SUBJECT: Forwards additional information interaction of corridor bldg
 w/Category I structures per NUREG-0857 & until 810819 ltr.

Subject: Palo Verde Nuclear Generating Station
(PVNGS) Units 1, 2 and 3
Docket Nos STN-50-528/529/530
File: 82-056-026; G.1.10

Enclosed please find our response to Section 3.7.2 of Reference (1) and
Item 19 of Enclosure 2, Reference (2), regarding interaction of the Corridor
Building with Category I Structures.

QUESTION 19: Provide justification that the Corridor Building has been designed to meet SRP section 3.7.II.8.

FIGURE 1 ELEVATION

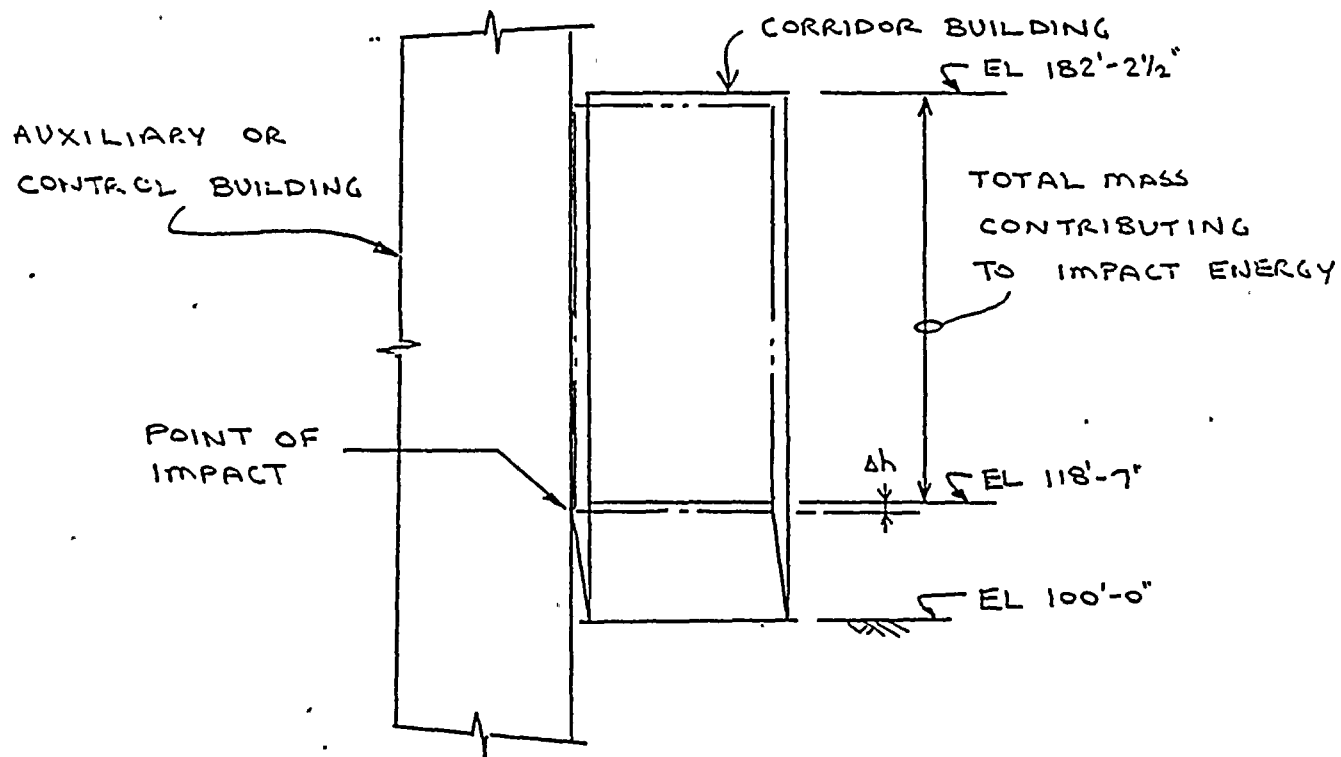
The cumulative impact energy of all elevations was assumed to be acting at one elevation (See Figure 1).

An elastic response spectrum analysis was performed in order to determine the maximum kinetic energy (i.e. maximum floor velocities) of the building. The kinetic energy was added to the potential energy associated with the decrease in elevation of the center of mass rotating about the base. This total impact energy was then used to calculate the required ductility of the structural elements of the Auxiliary and Control Buildings.

FIGURE 2 PLAN

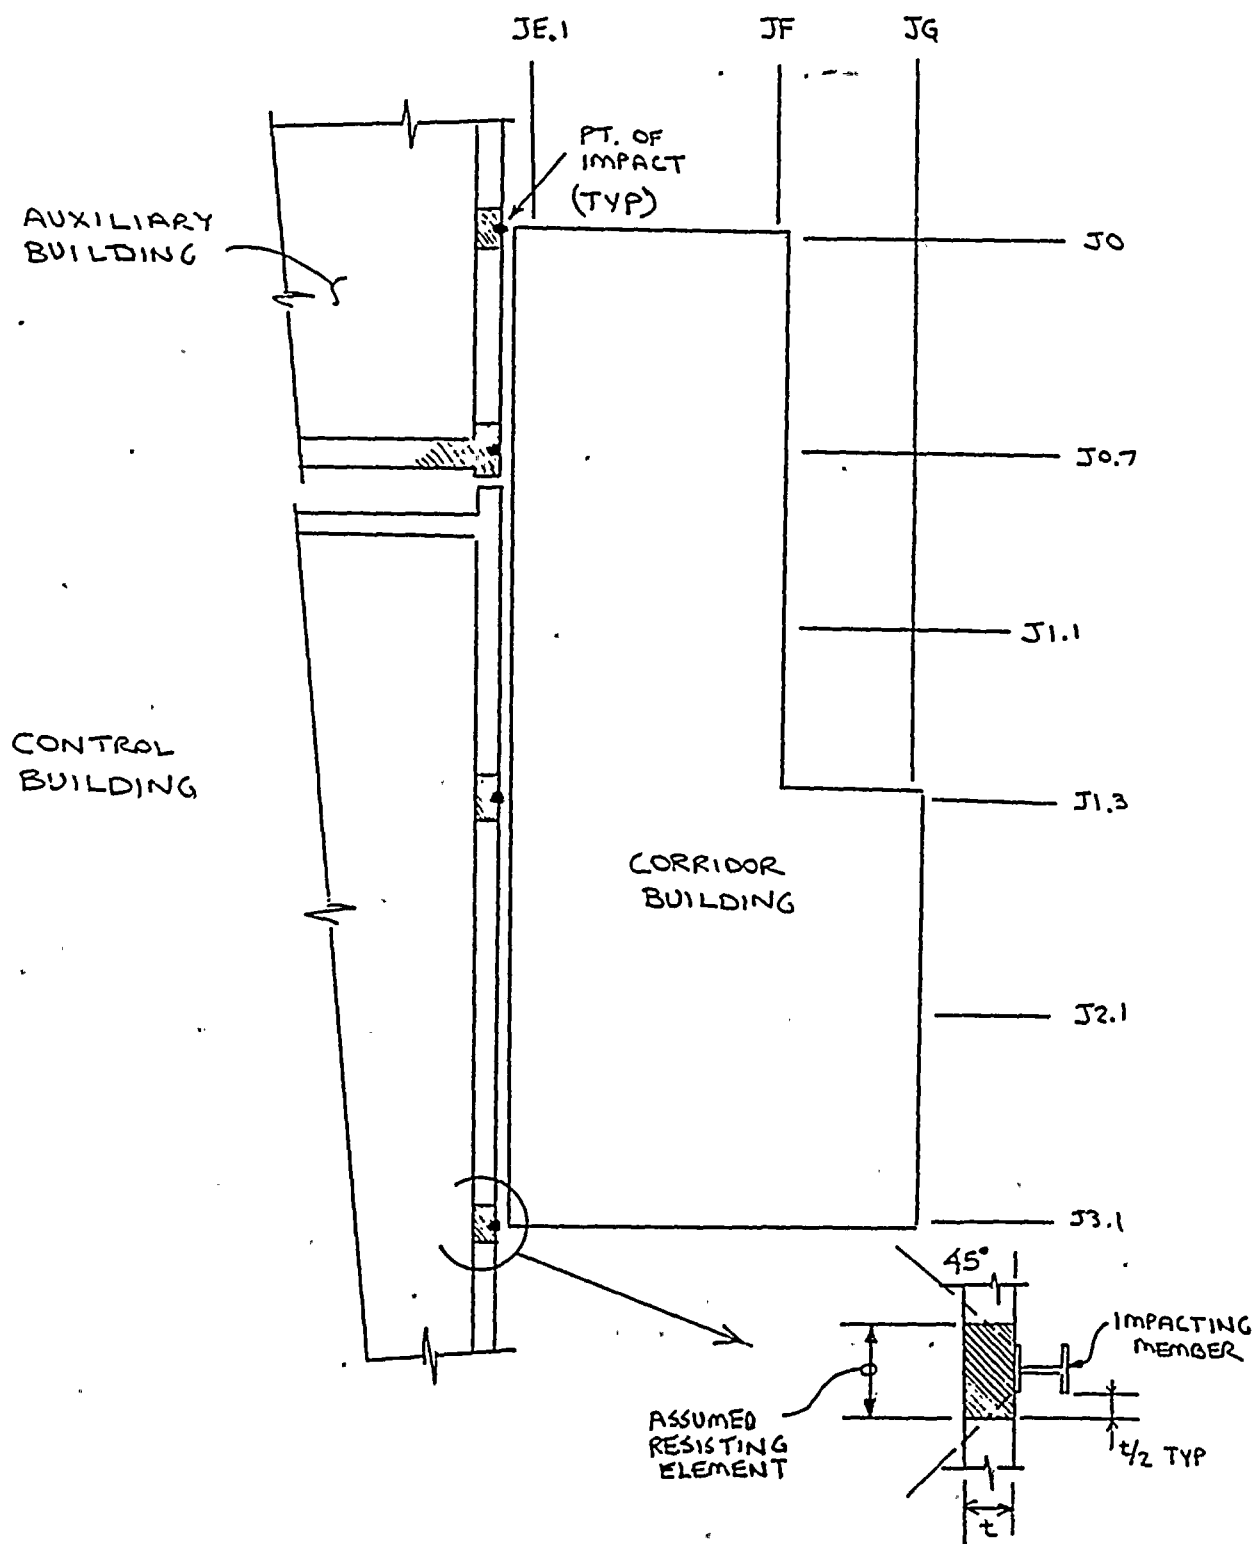
Only a narrow vertical strip of the Auxiliary and Control Building walls was assumed to resist the impact energy (i.e. one-way action) (See Figure 2).

FIGURE 3 PARTIAL SECTION

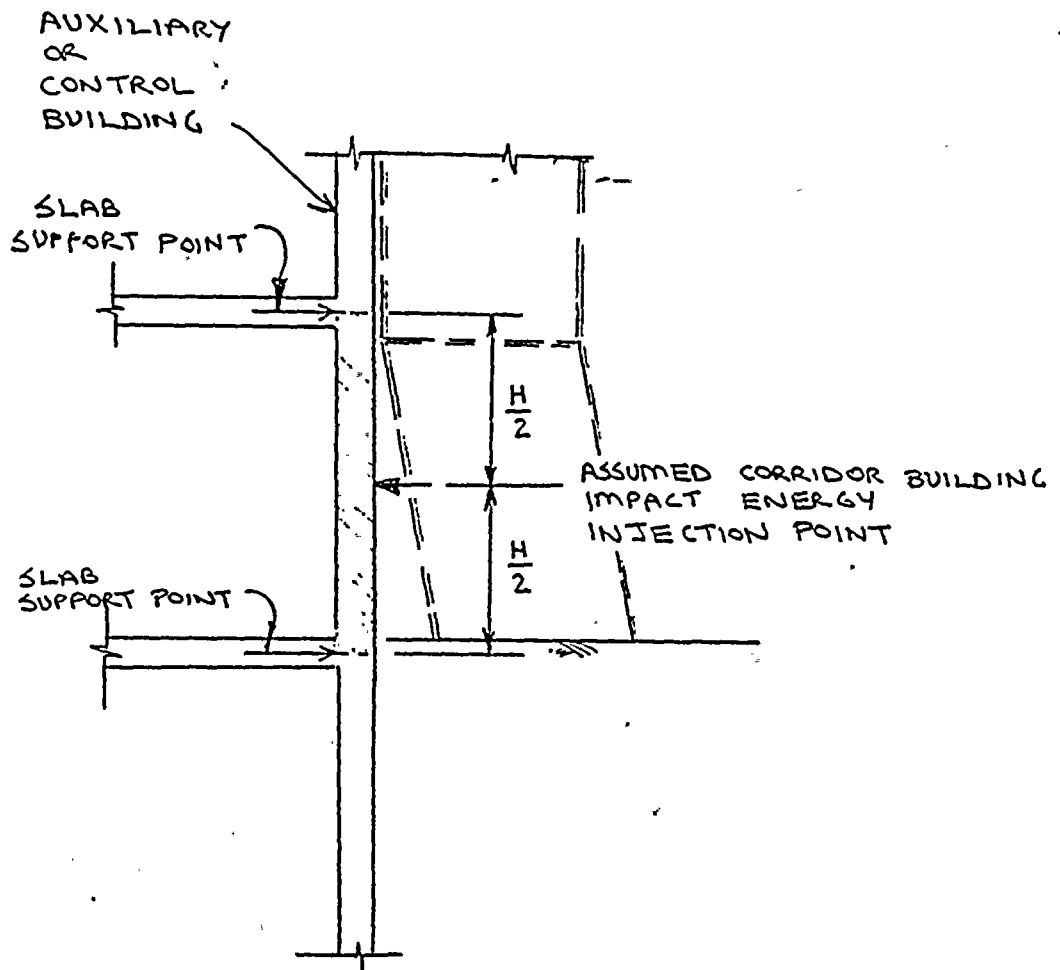
The impact energy was applied at the mid-story height of the Auxiliary and Control Buildings rather than the actual slab elevation (See Figure 3).
